## CHAPTER 3 ERRATA AND CHANGES

**ATWATER-MERCED EXPRESSWAY**

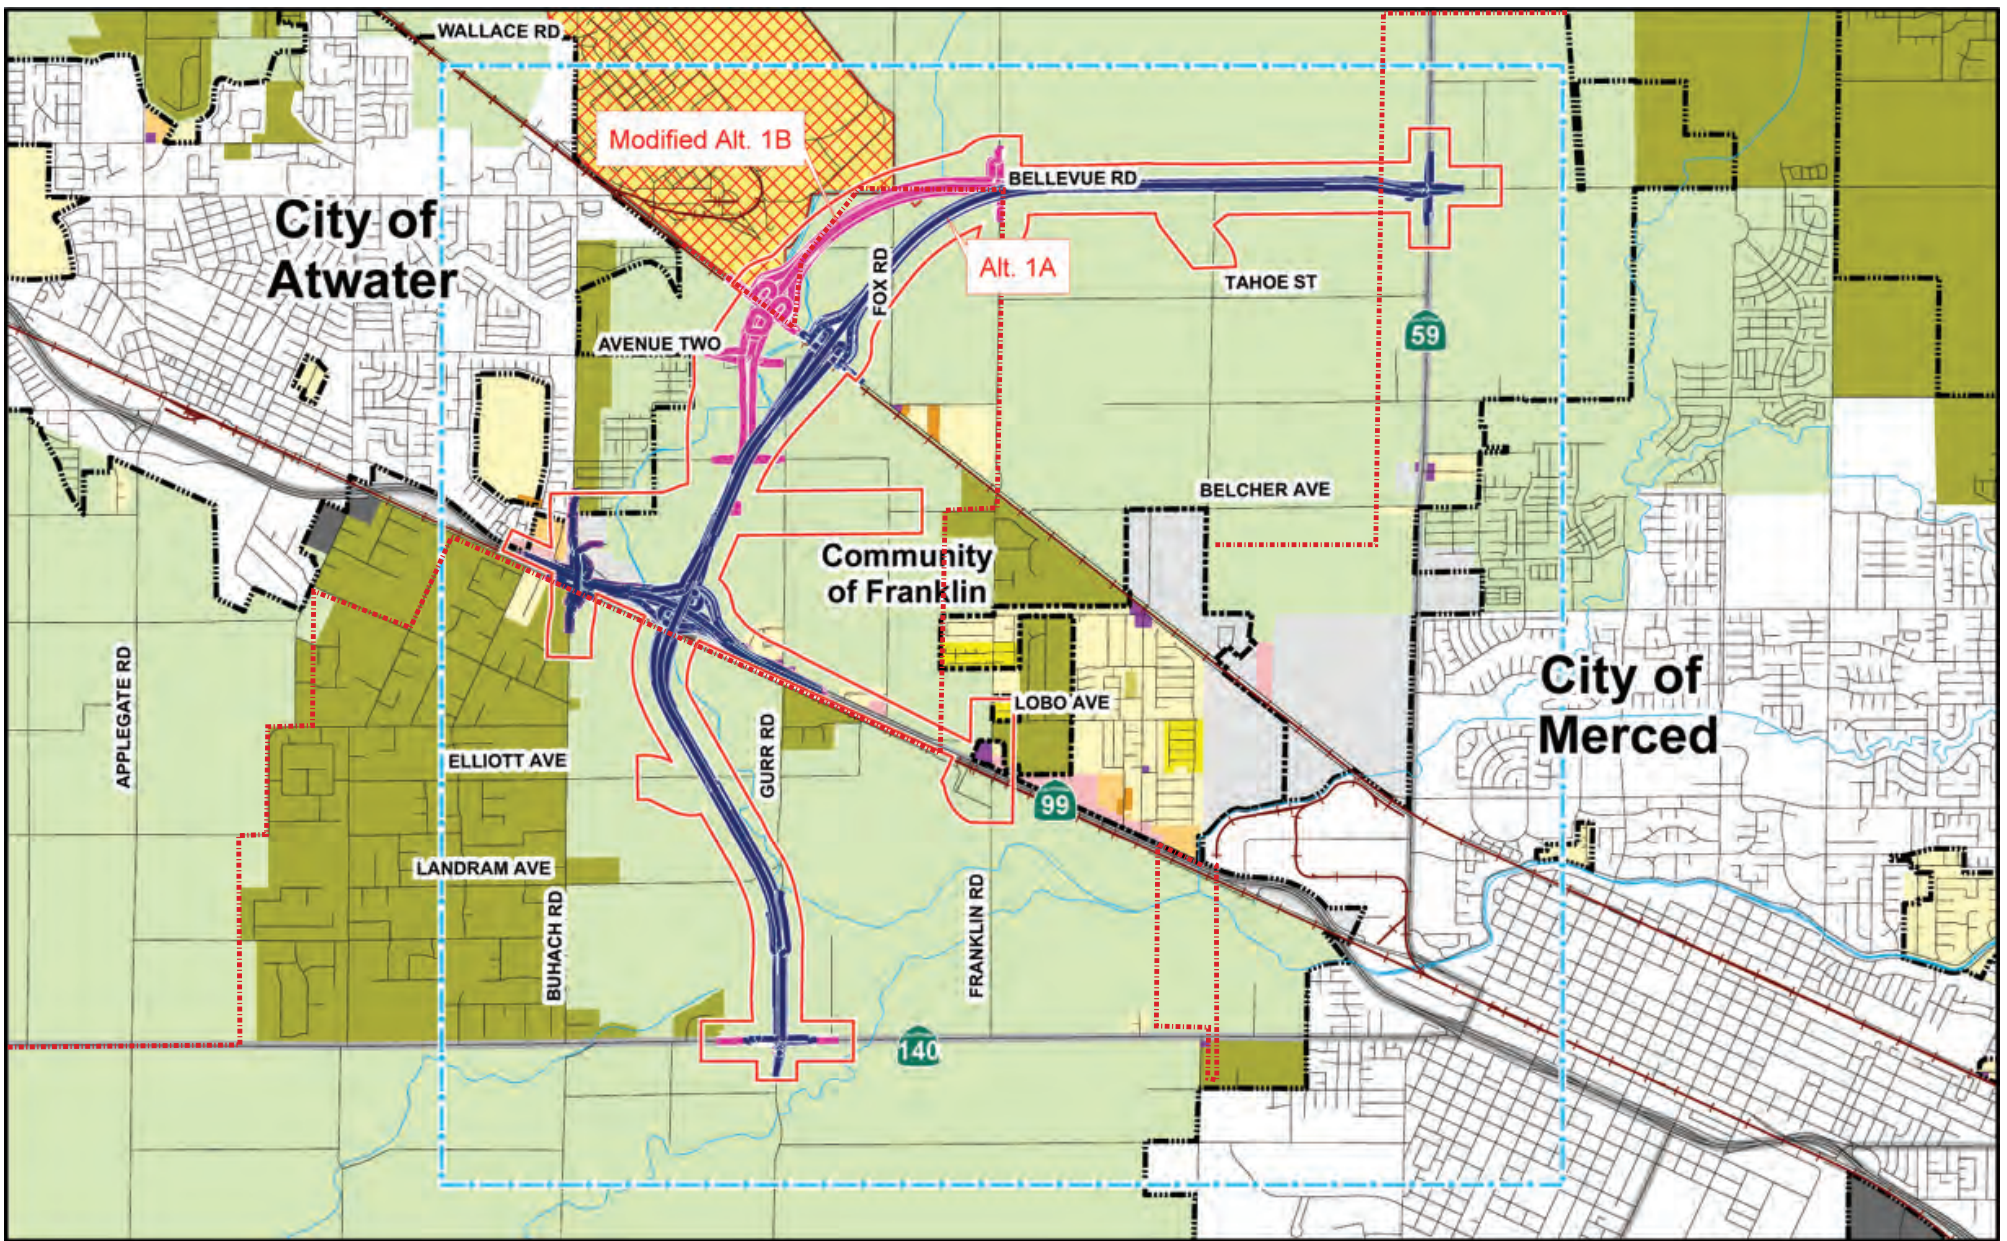
*Section 4.2, Land Use and Agriculture: Figure 4.2-2, the legend has been revised based on comments received on the March 2008 Draft EIR.*
